HL-5963

**Edwin I. Hatch Nuclear Plant**  
**Additional Information Related to the Staff's Review of Severe**  
**Accident Mitigation Alternatives (TAC Nos. MA8096 and MA8098)**

**OFFICE OF NUCLEAR REACTOR REGULATION  
REQUEST FOR ADDITIONAL INFORMATION (RAI)  
RELATED TO THE STAFF'S REVIEW OF  
SEVERE ACCIDENT MITIGATION ALTERNATIVES  
RELATED TO LICENSE RENEWAL FOR THE EDWIN I. HATCH NUCLEAR PLANT,  
UNITS 1 AND 2 (TAC NOS. MA8096 AND MA8098)**

Figure 1.b-1 Initiator Distribution Hatch Unit CDF

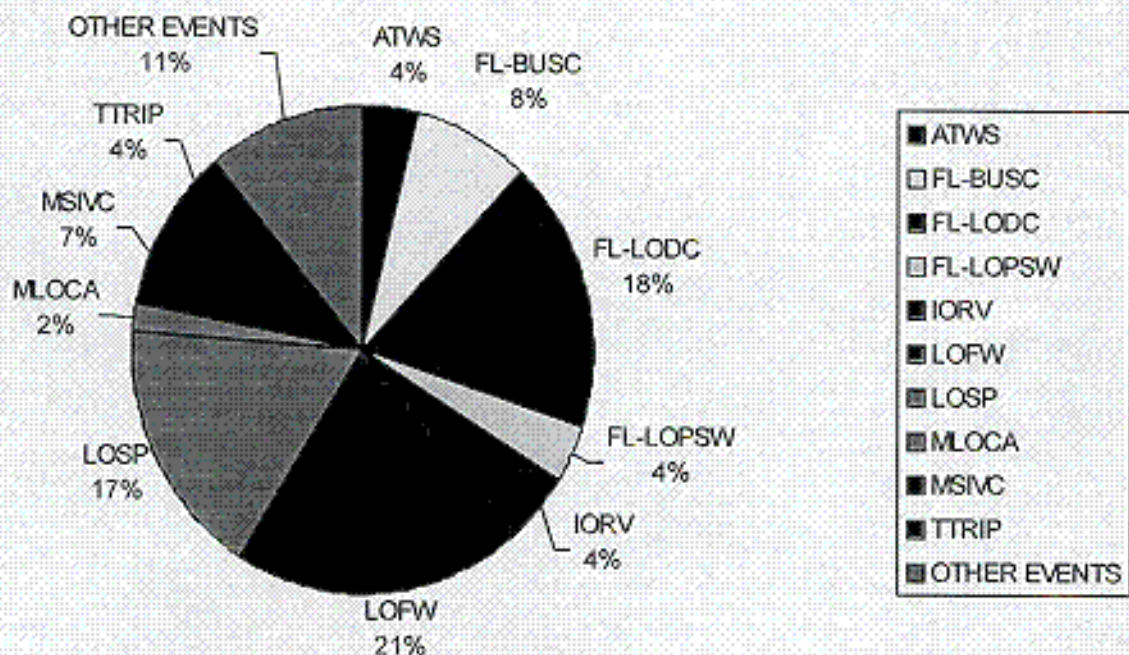
- a. **"A specific reference for the probabilistic risk assessment (PRA) study, and a description of the internal and external peer review of the Level 1, 2, and 3 portions of the study."**

The tables and pie graphs presented in figures 1.b-1 and 1.b-2 provide CDF and large early release fraction (LERF) information regarding Unit 1 major initiating events. The response to RAI question 1.e provides the insight in terms of major contributors (hardware and human failures).

Figure 1.d-1 Hatch Containment Event Tree

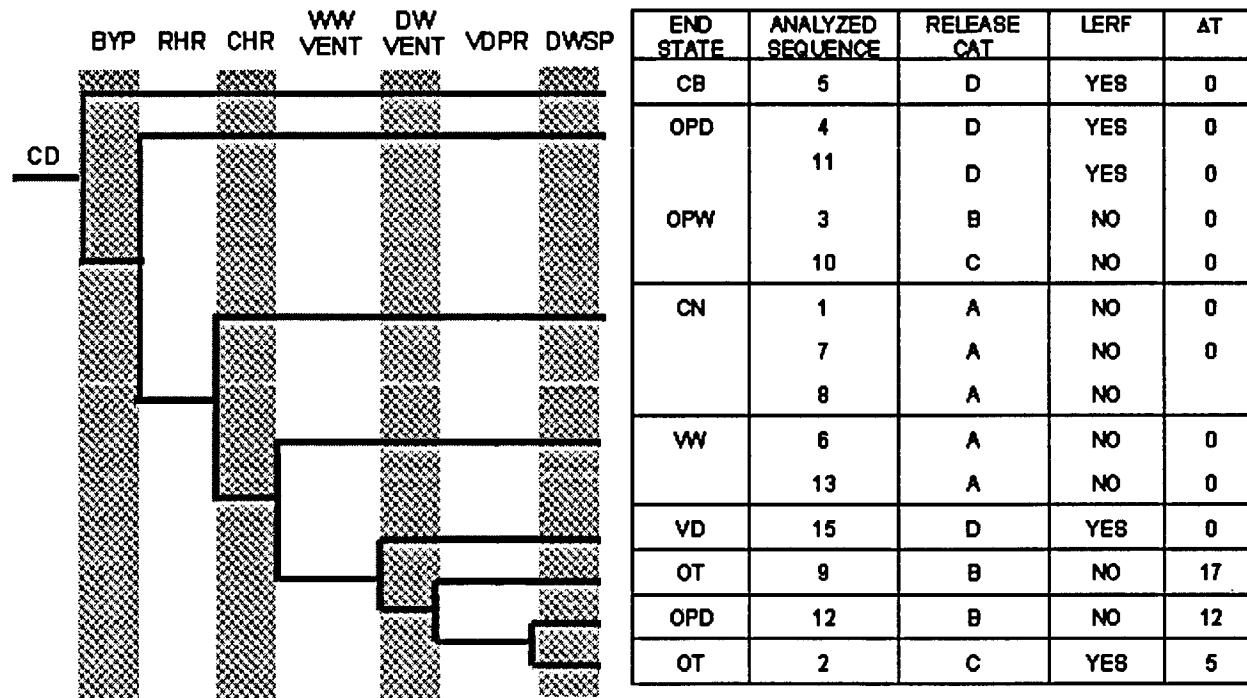
- c. **“A listing of the dominant Level 1 accident sequences including the sequence logic in terms of event tree top events, and a mapping of these sequences to the Level 2 release categories. Provide sufficient supporting material to allow an outside PRA reviewer to understand the sequences and mappings.”**

The LERF model is based on a CET developed by Fauske and Associates (see Hatch Containment Event Tree, figure 1.d-1). This tree was used to construct the LERF model for the Hatch PSA. Details of this construction are described in Attachment 2 with Attachment 1 describing the core damage model interface. Comparison of this tree to the IPE version shows a great simplification. Due to the direction of the nuclear PSA industry and the NRC, only large early releases were considered. The Hatch definition of LERF is as follows: A rapid, unscrubbed release of airborne aerosols within 6 hours of the time between vessel failure and containment failure. In
